Revised Handicap Ramp

Comyn Hall 601 Park Street 1/8/2013

DATE: October 10, 2012 SUBJECT: **601 Park Street**

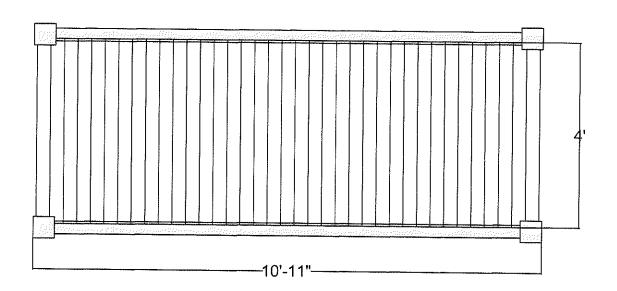
Did you get a chance to review the Park Street HC ramp?

7. Improve the quality of the handicap ramp. It was suggested that it be modeled after the one at the Hospice House on Park Street.

## The ramp is approved as submitted.
